SCI-823-0.00
PID Nos. 19415, 77366, 79977

Value Engineering Study Report
Draft Stage 2 Design Phase

re: SCI-823-0.00, PID Nos. 19415, 77366 and 79977, Portsmouth Bypass
Harrison, Jefferson, Madison and Porter Townships, Scioto County
Value Engineering Study Report

SITE PLAN
BRIDGE NO. SCI-823-1593
RAMP B OVER FAIRGROUND ROAD

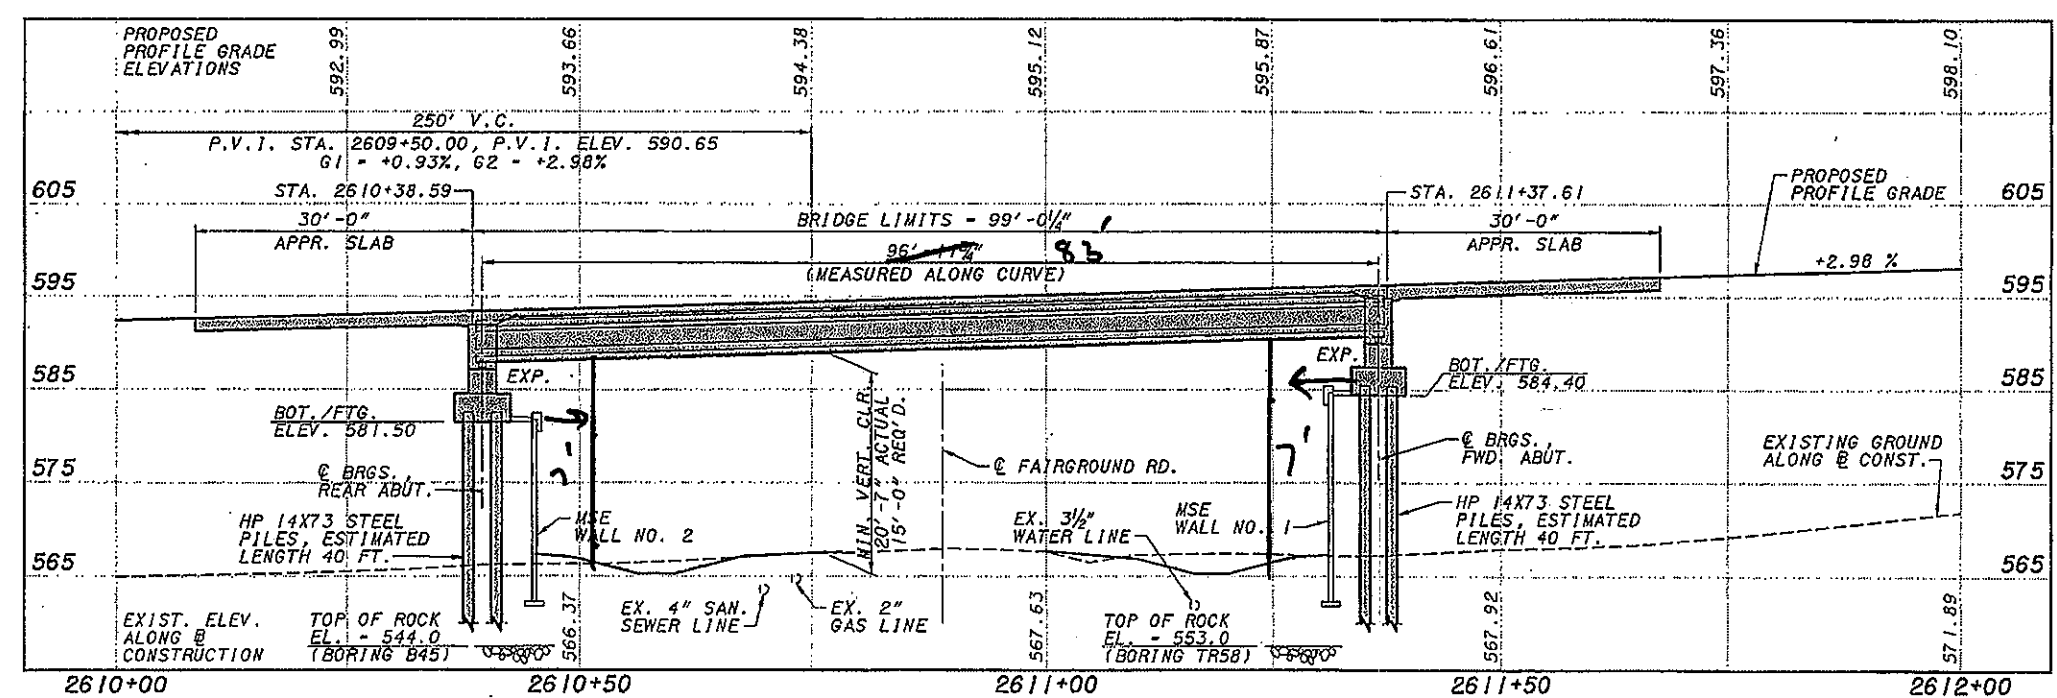
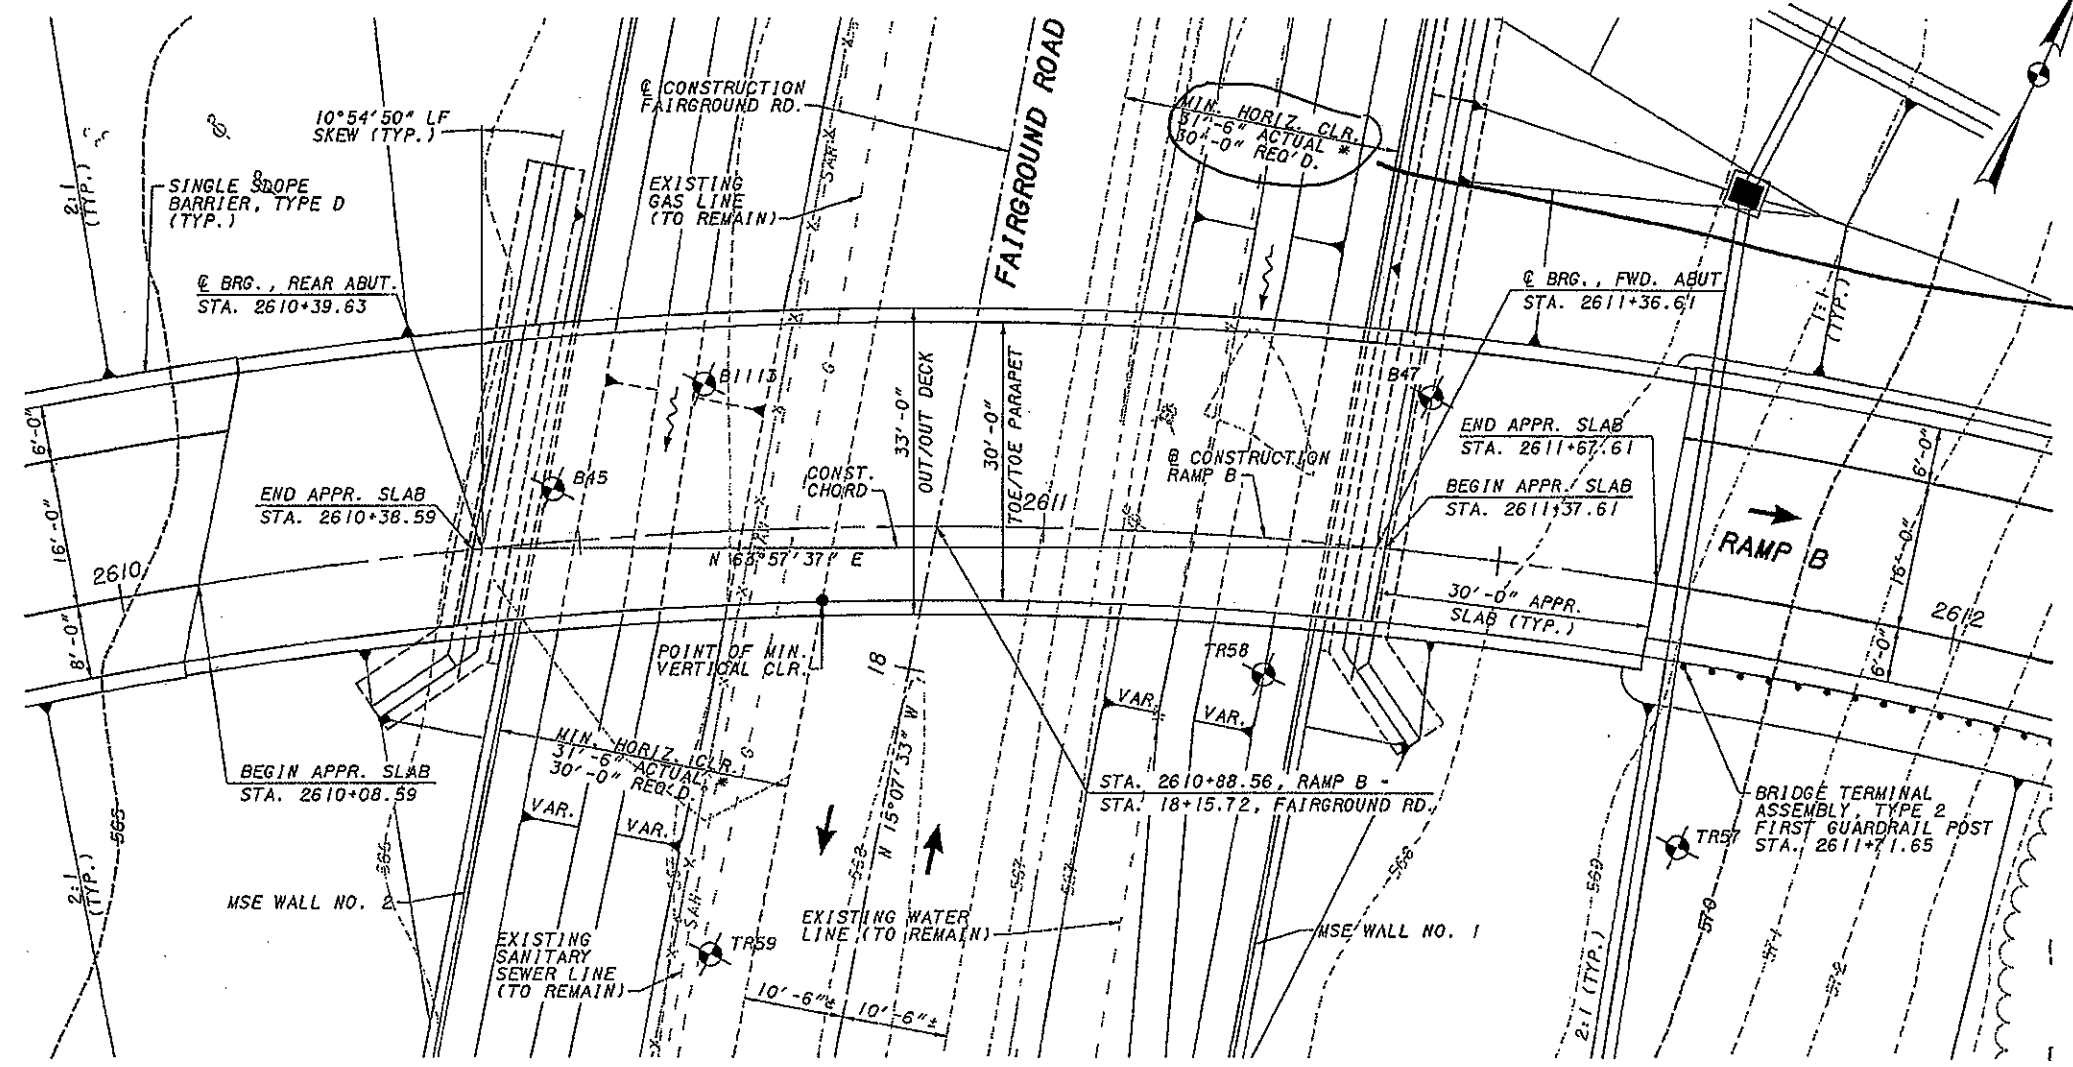
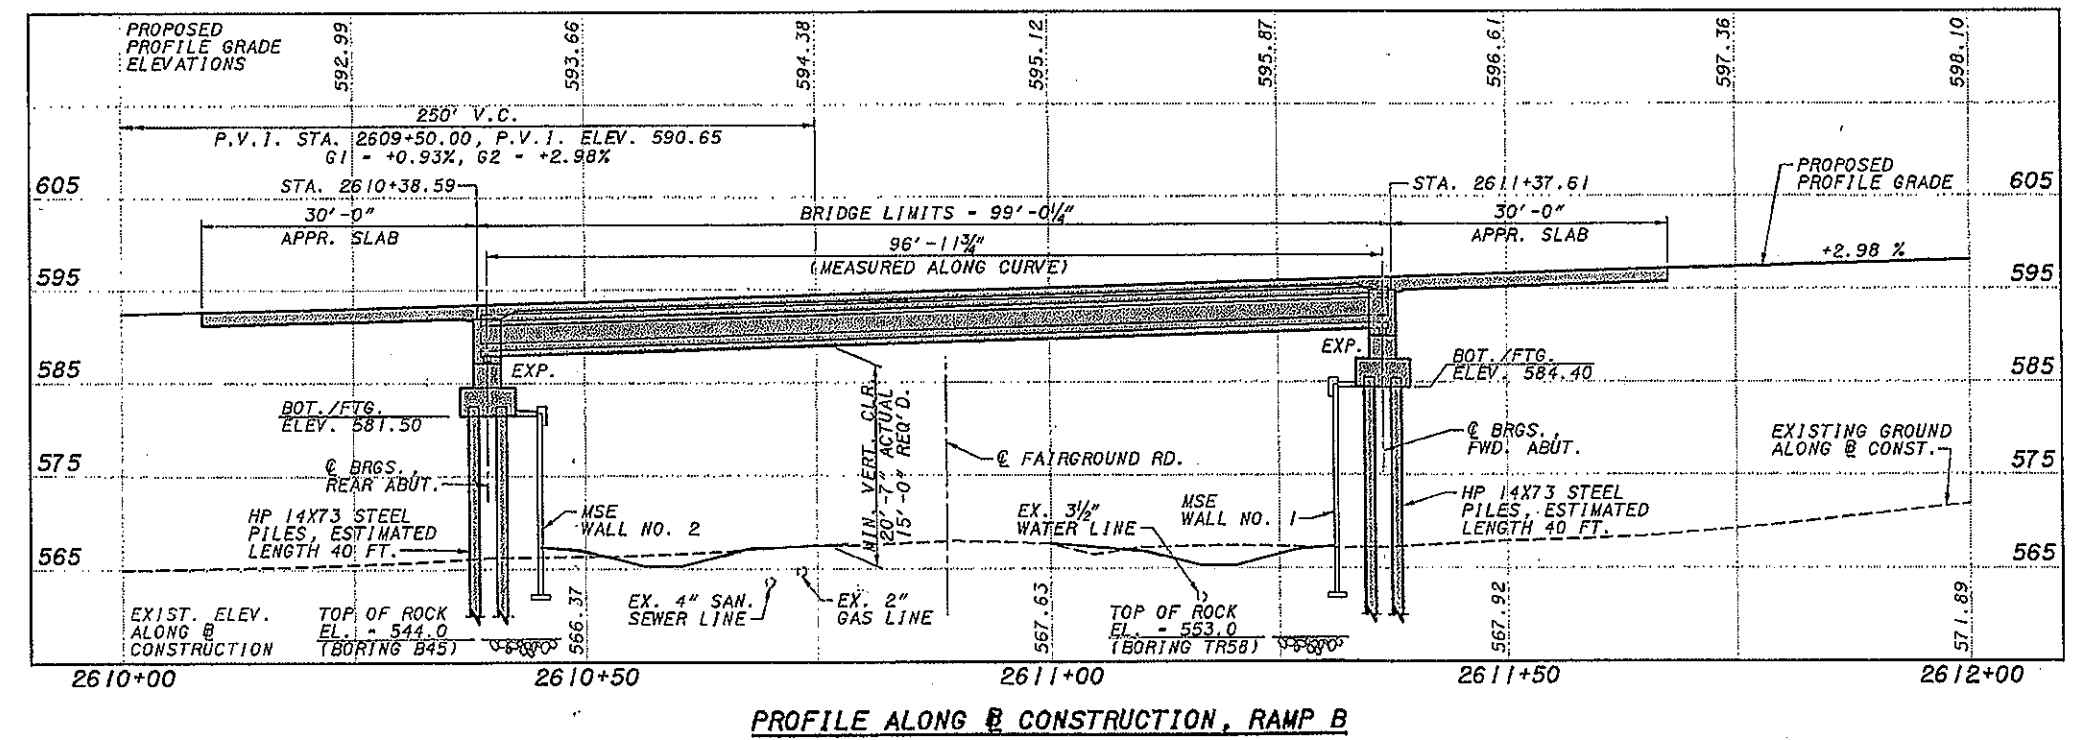
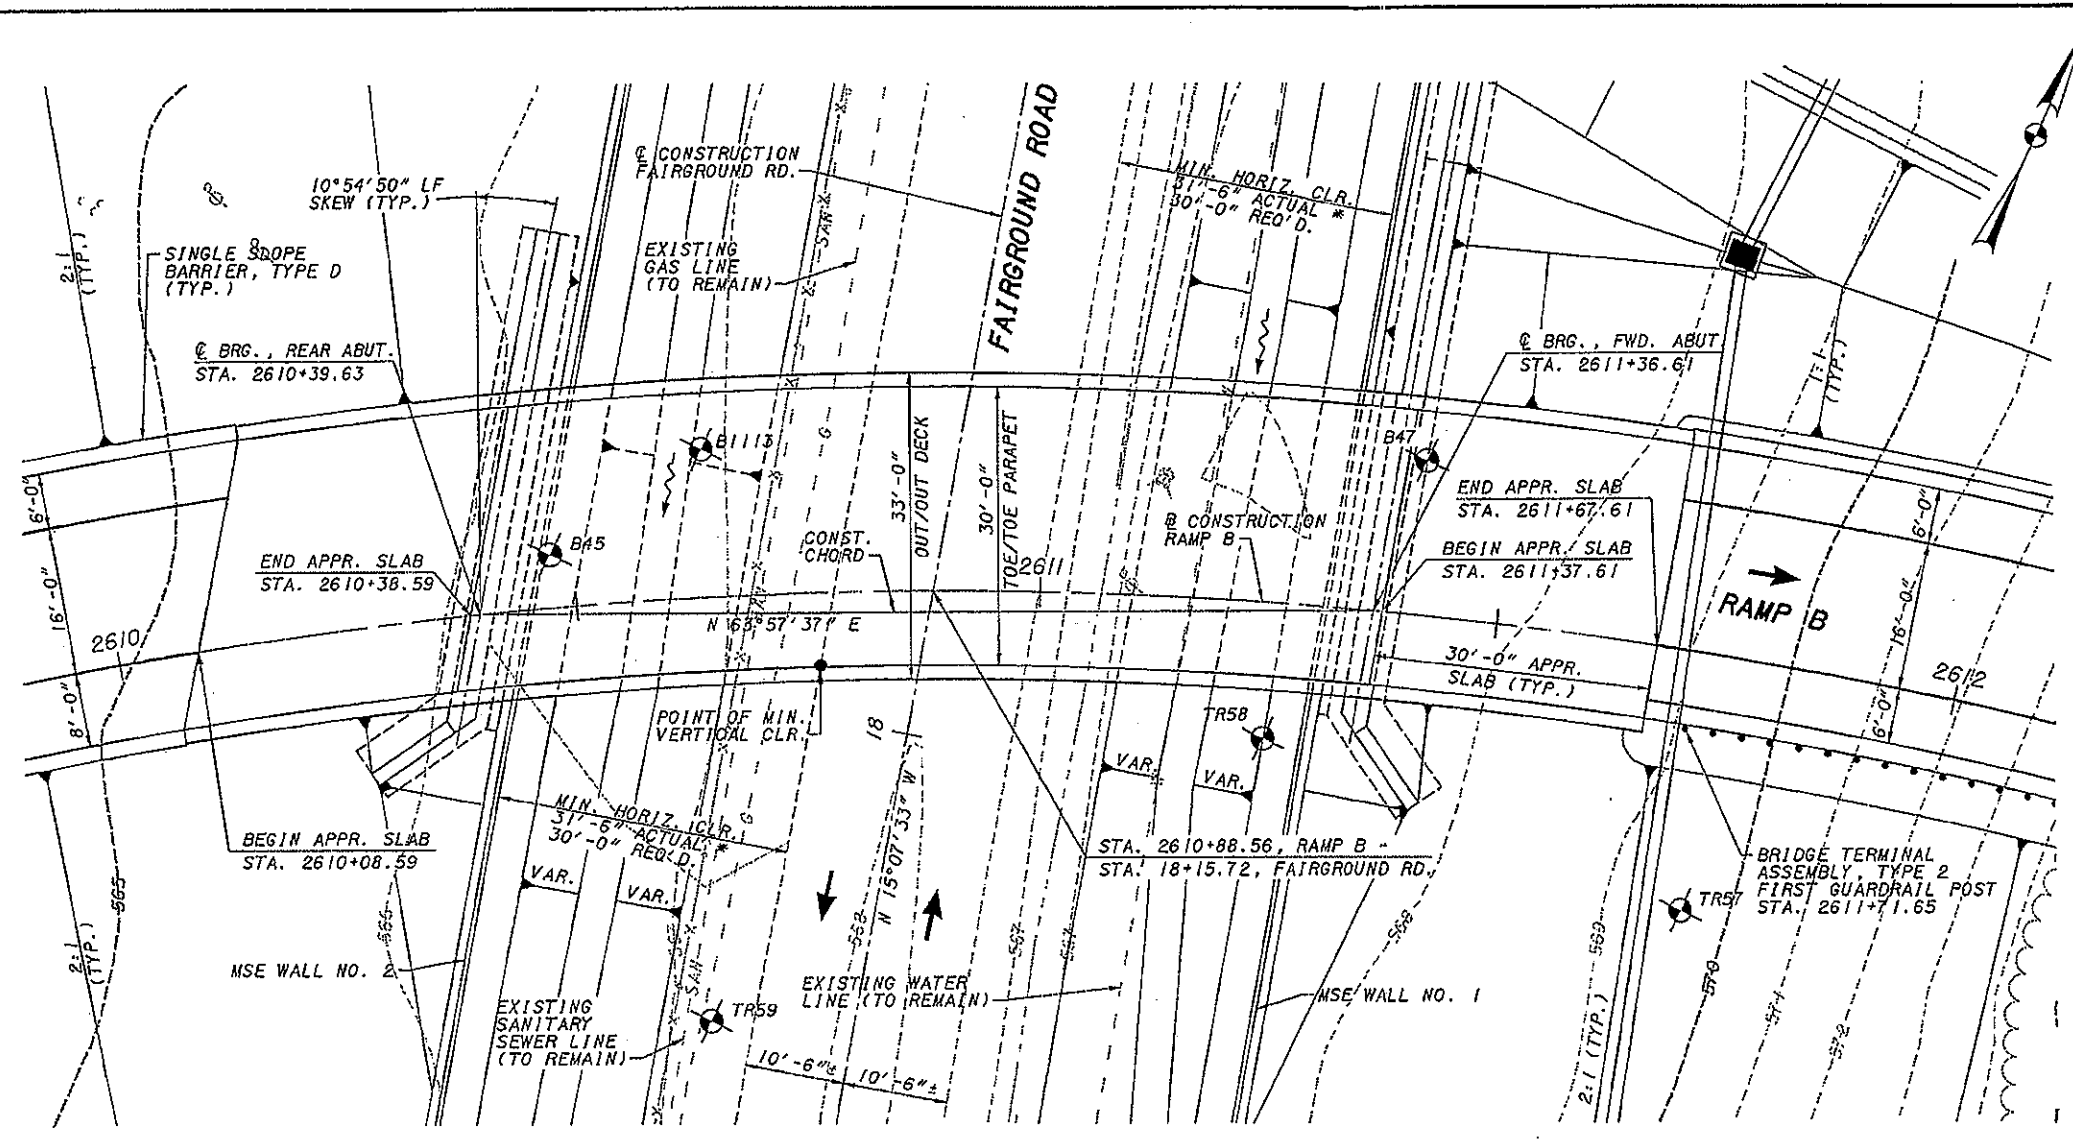
- SCI-823-1096 L & R - No change;
- SCI-823-1357 L & R - No change;
- SCI-823-1593 Ramp B - Potential to shorten span 14 ft. based on the required horizontal clear zone;
